**STAFF RECOMMENDATION**  
**1003 Russell Street**  
**March 15, 2017**

**Application:** New construction – addition; Setback determination  
**District:** Lockeland Springs-East End Neighborhood Conservation Zoning Overlay  
**Council District:** 06  
**Map and Parcel Number:** 08309020800  
**Applicant:** John Root, RootArch  
**Project Lead:** Paul Hoffman; paul.hoffman@nashville.gov

**Description of Project:** Addition and alterations to a non-contributing building. A setback determination is requested for the front and left sides, from fifteen feet (15') to ten feet (10') and six feet (6') respectively.

Figure 3. Proposed front elevation, showing the new butterfly-roof patio covering.

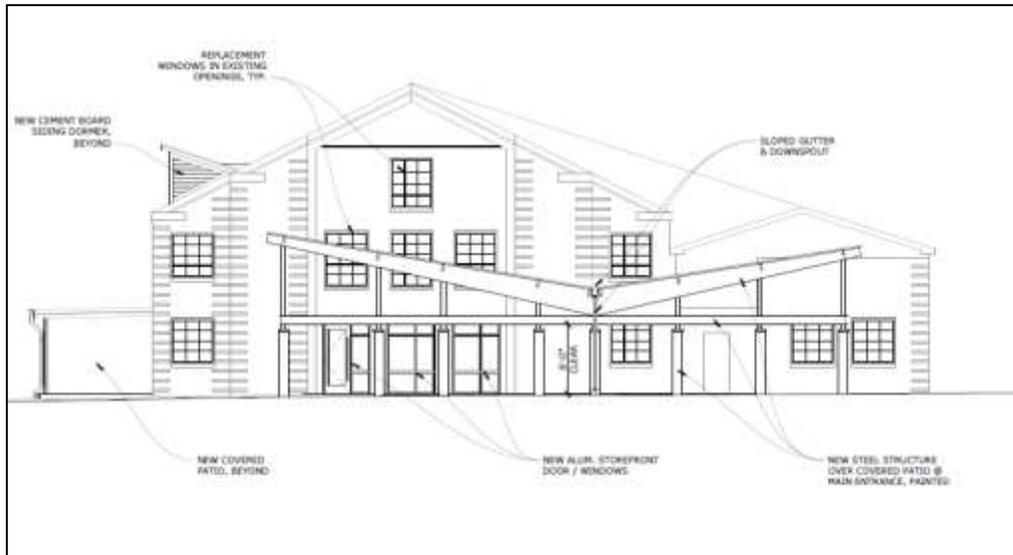
Design, Location & Removability: The additions include a front covered patio and a left side covered patio. Typically, additions should be at the rear of buildings but since this building is not historic and does not negatively alter the orientation or appropriate setbacks, Staff finds the location to be appropriate.

**Roof form:** The front covering will have a steel butterfly-roof covering with steel pedestals and posts. A butterfly roof is not a roof form found historically in the district but Staff found it to be appropriate for several reasons. The building is not historic and is located in an area of low historic context. The covering will bring the building closer to the street, which is in keeping with the historic commercial context in the district and the covering will tie in a right-side addition that, in its current design, is not compatible with the original form of the building.

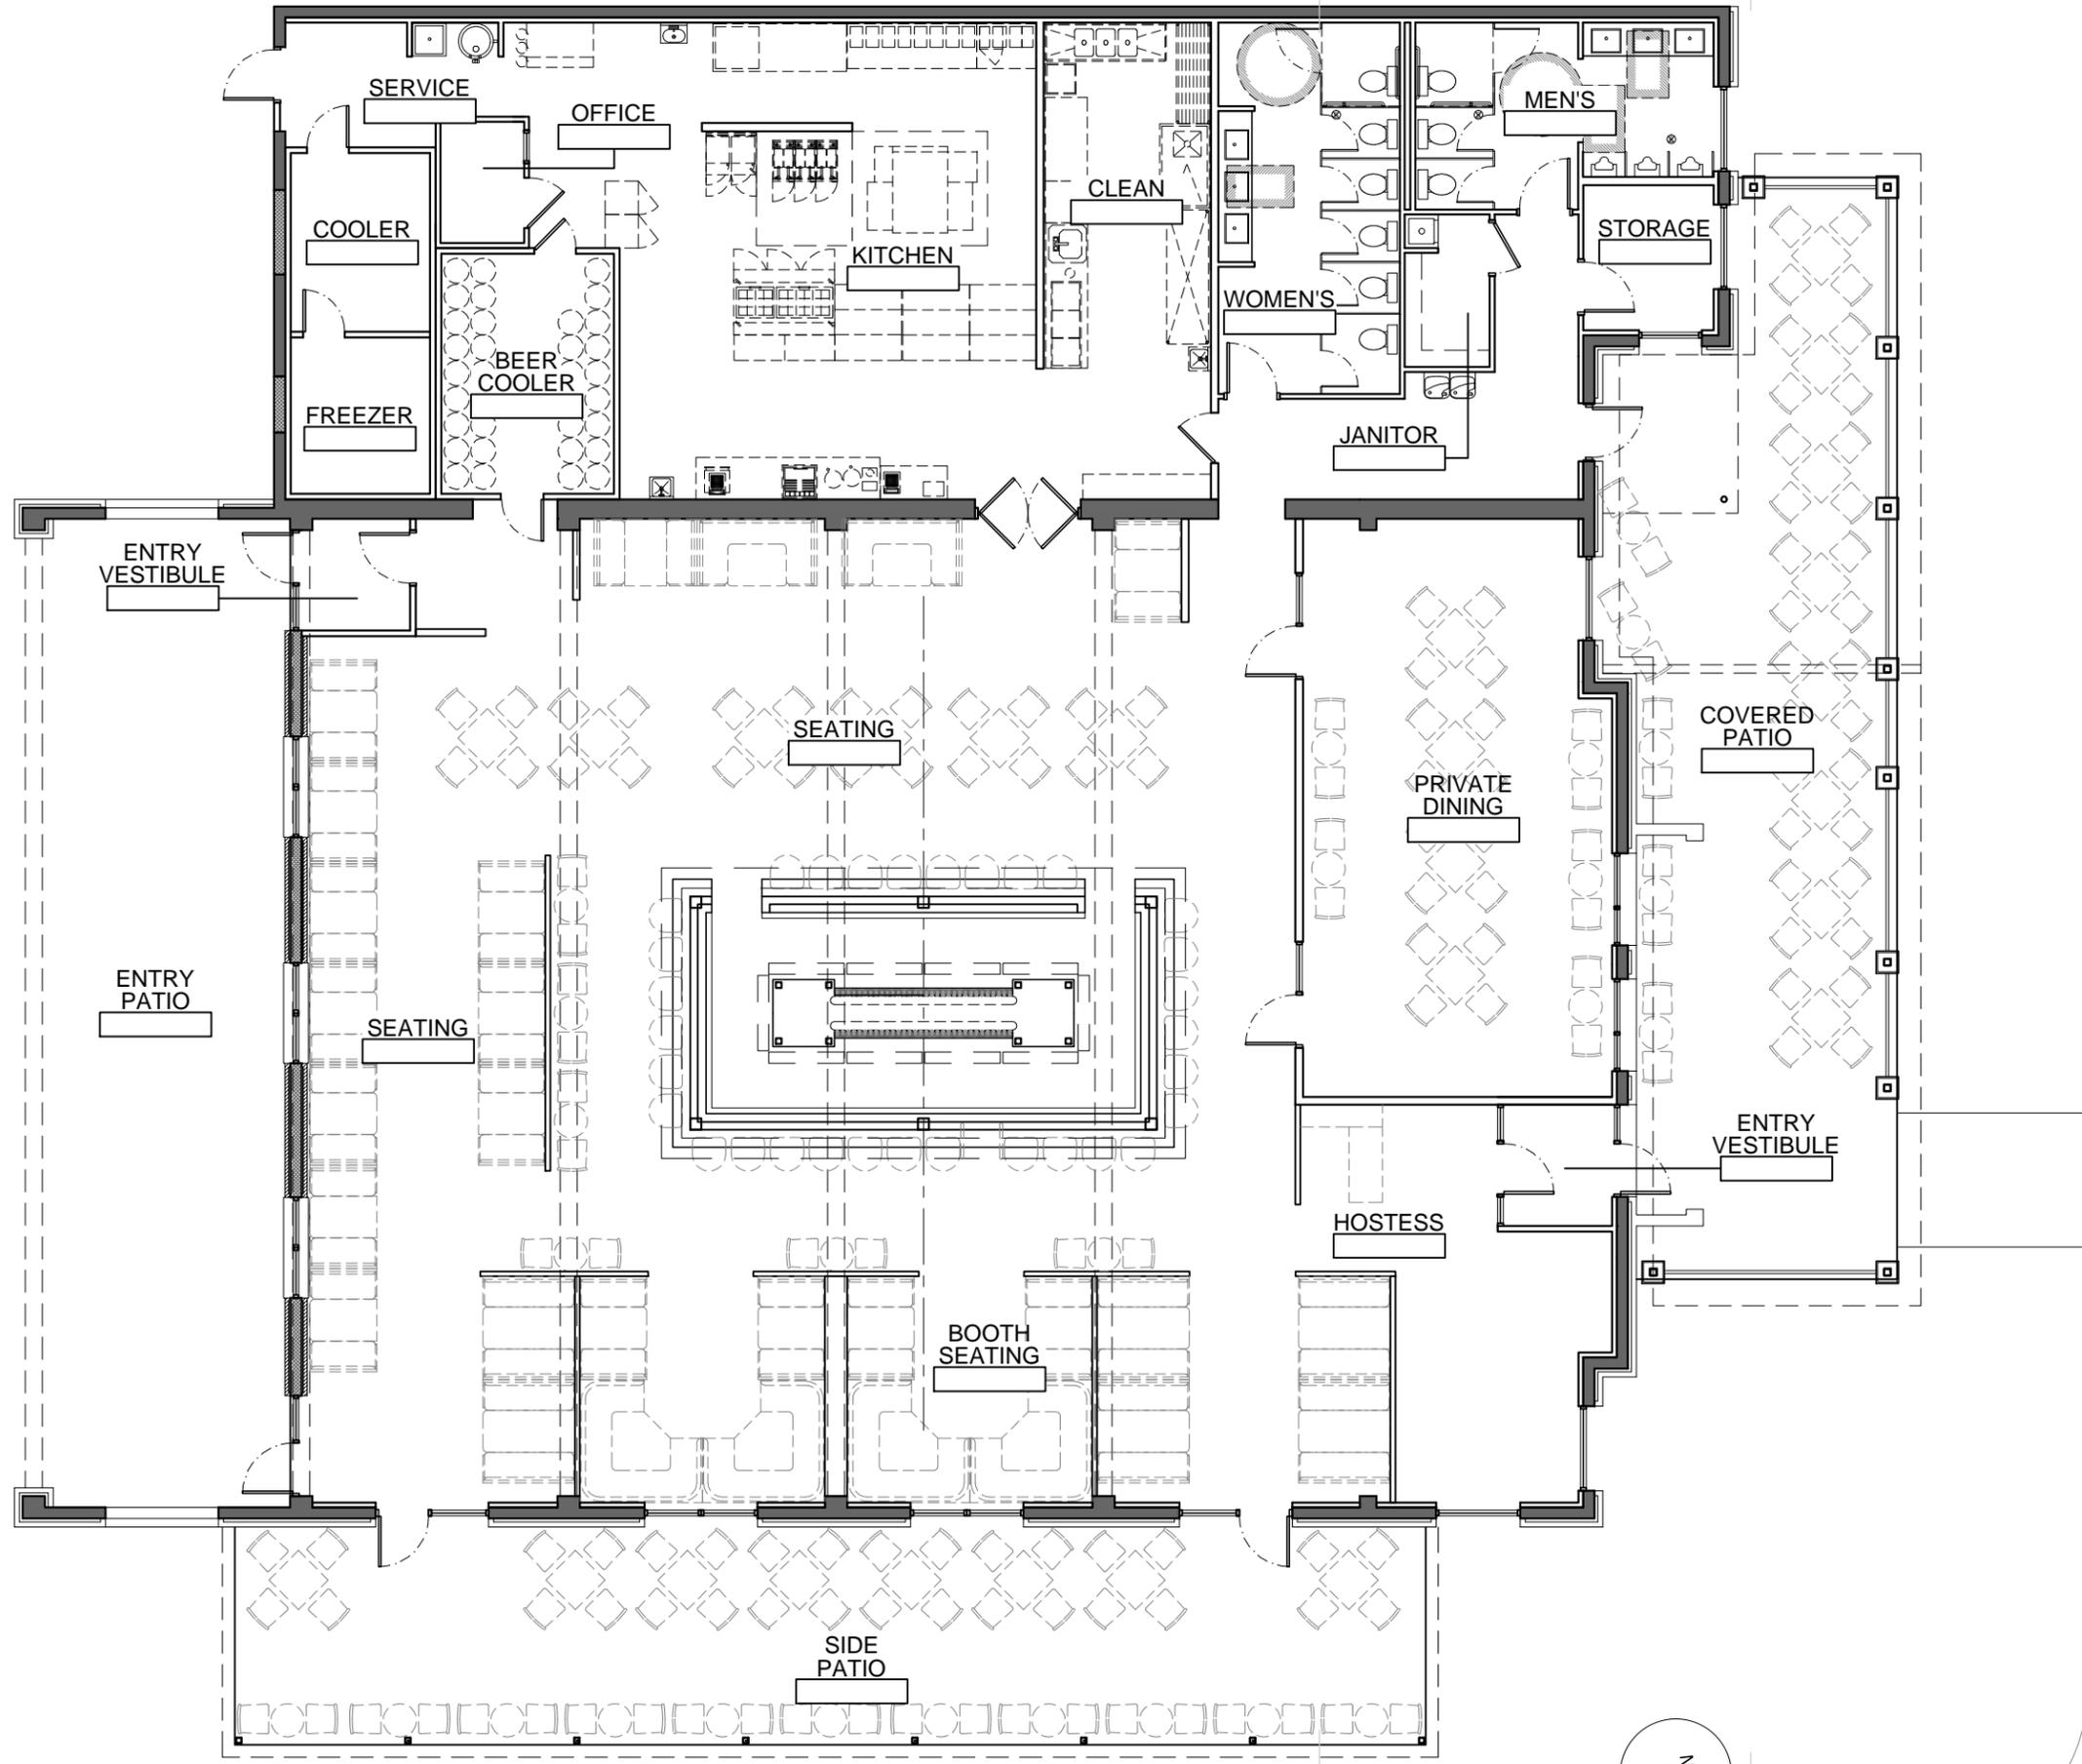
Three new dormers will be added to the west side of the building’s roof. Dormers are a typical roof feature of historic buildings in the district. Unlike typical shed roof dormers these slope up at the front wall of the dormer rather than down. This design is appropriate as the building is not historic and there is little historic context. Staff finds that the project meets section II.B.5.

NORTH ELEVATION

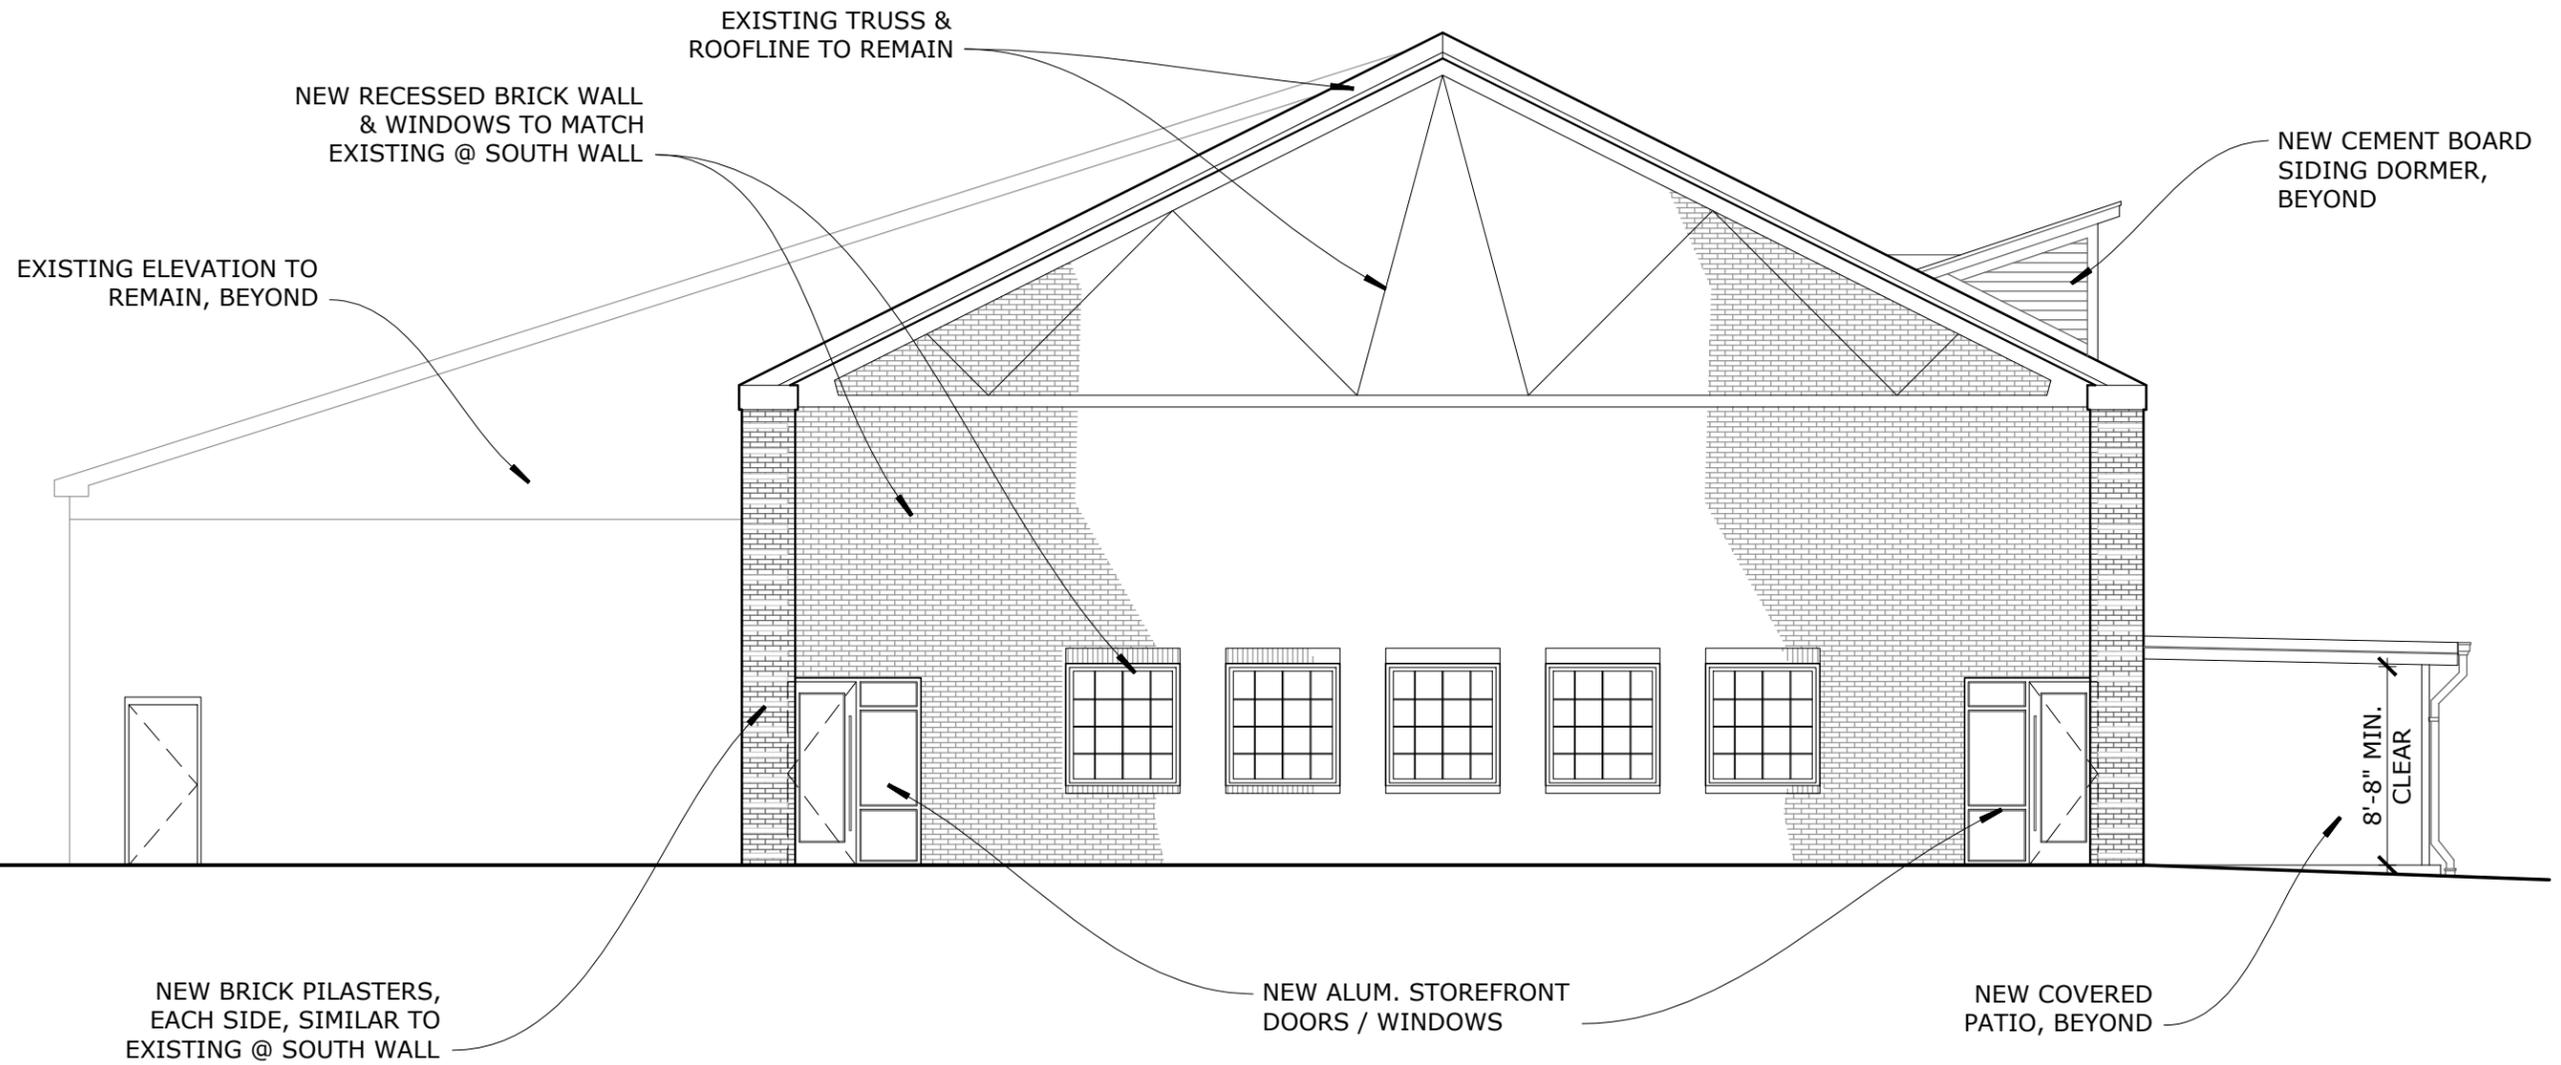
**Proportion and Rhythm of Openings:** The existing fenestration is not proposed to be changed. The new north side of the building is a brick wall with five windows across. The new window openings are similar to the proportion of the building’s existing windows. There are no large expanses of wall space without a window or door opening. Staff finds the project’s proportion and rhythm of openings to meet Section II.B.7.

SITE DEMOLITION PLAN

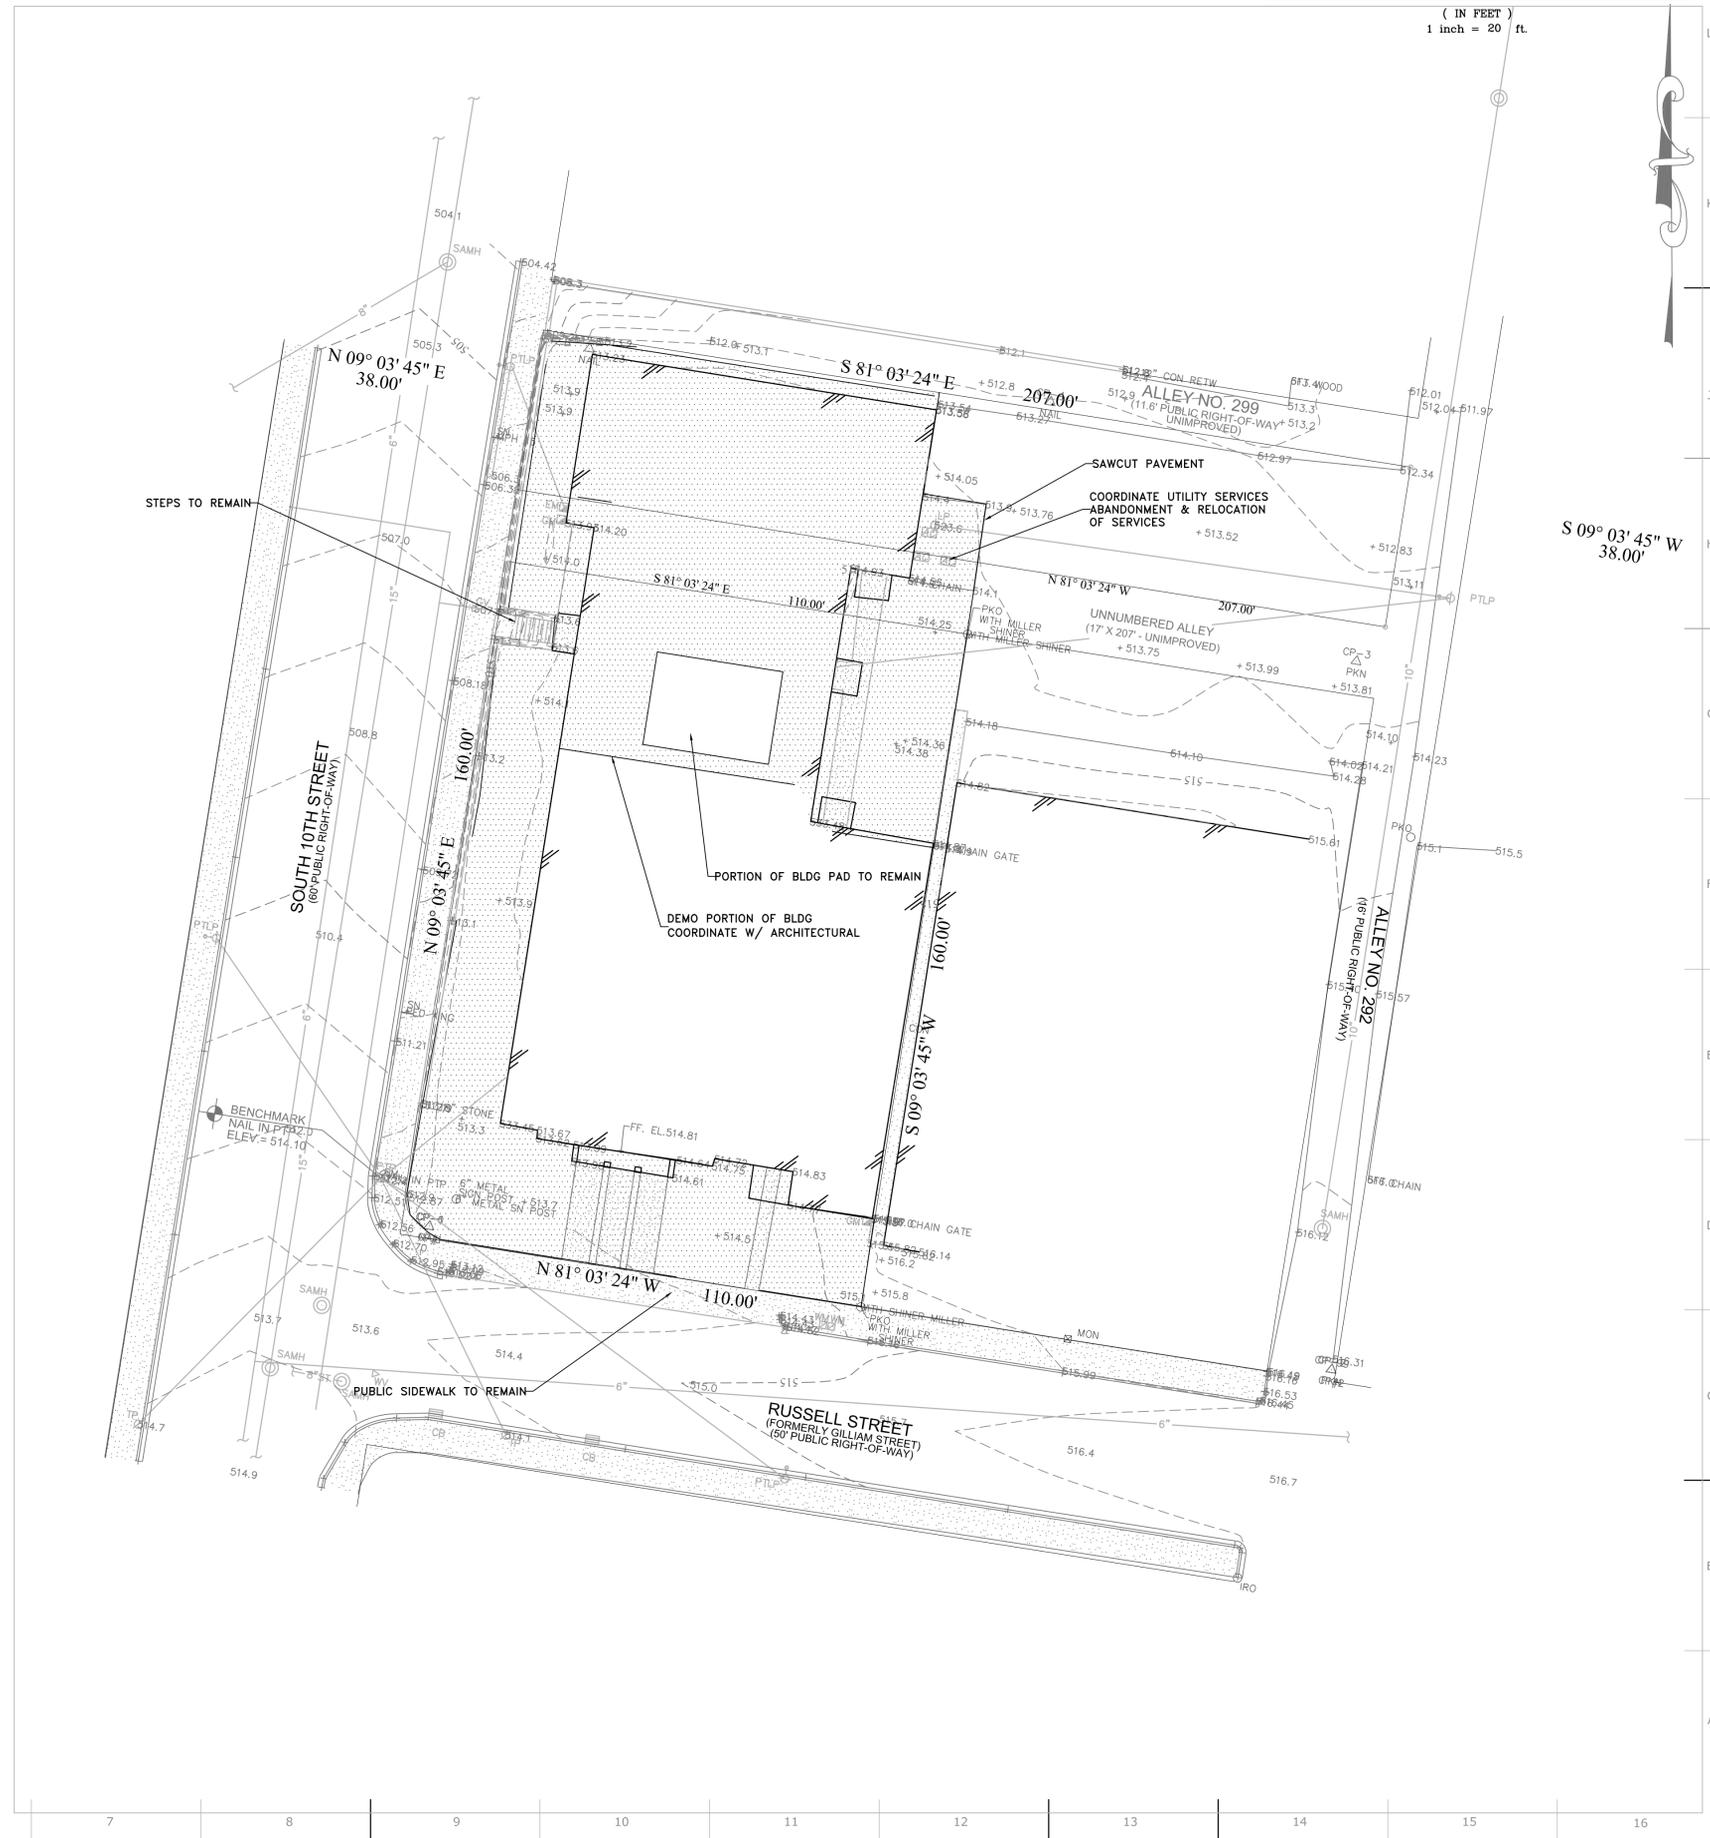
**Demolition:** The north side of the building is proposed to be demolished. The primary portion of the structure facing Russell Street will remain (see Figure 2) with several exceptions. The brick columns and steeple will be removed. All windows and doors will be replaced and some windows will be turned into doors. One rear, left-side window will be removed and not replaced as it will look into an open rear patio created by the removal of the rear wall.
